FINAL PLAT

OLD HIGHWAY 51 INDUSTRIAL PARK

PUD 000502-2022

Markup Summary (CFP)

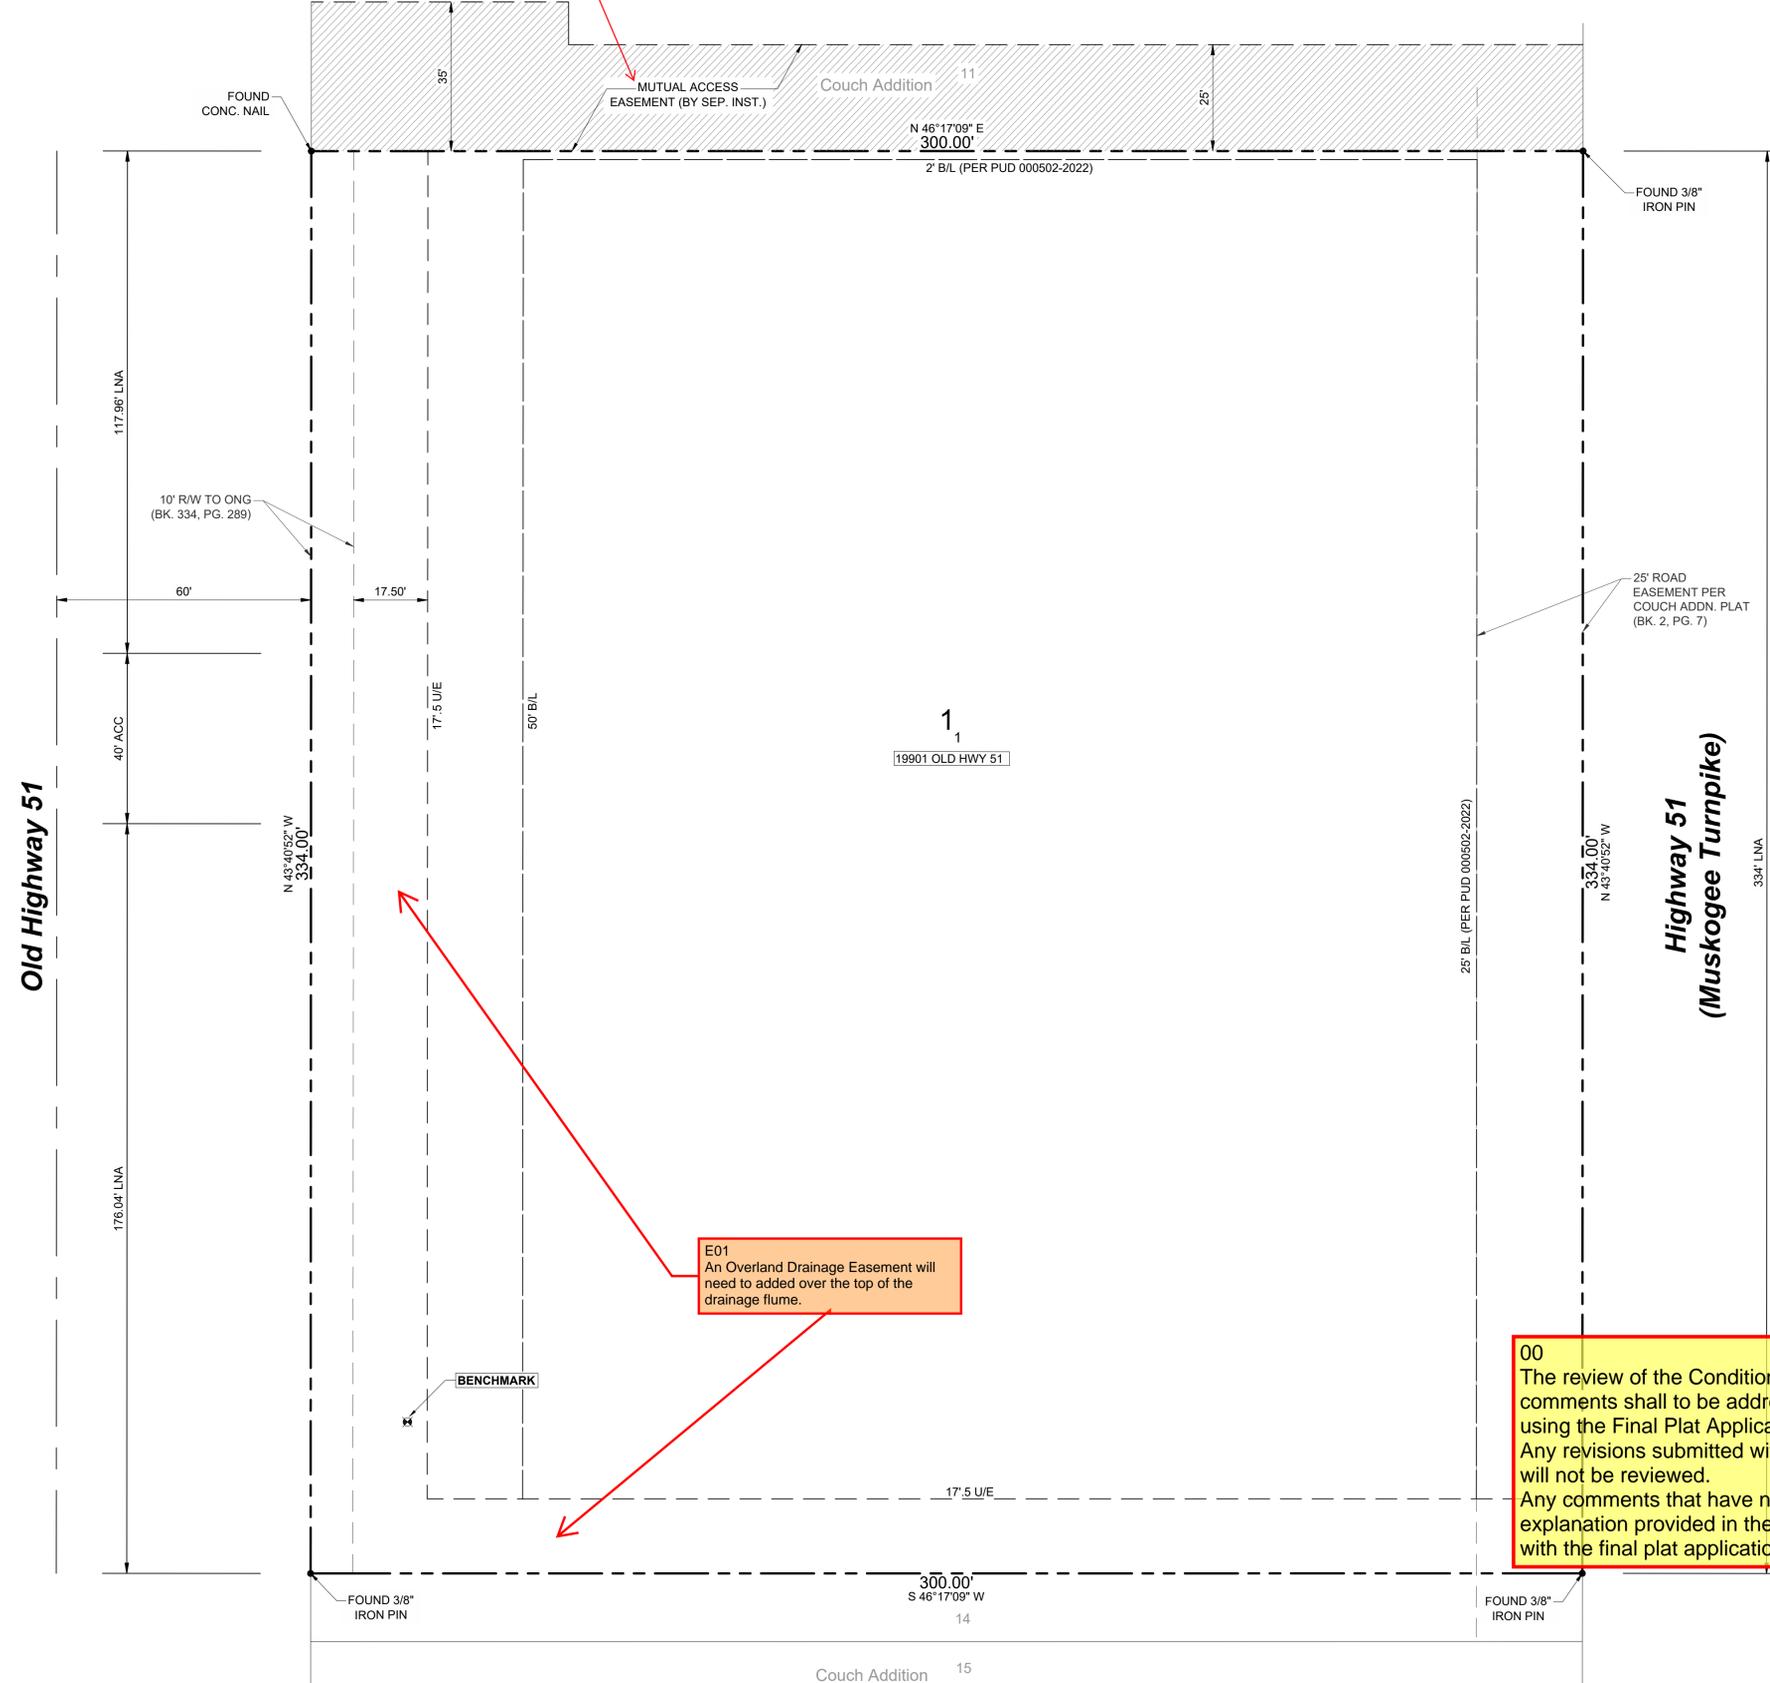
P01:
 Please provide the document number for easements by separate instrument

E01
 An Overland Drainage Easement will need to added over the top of the drainage flume.
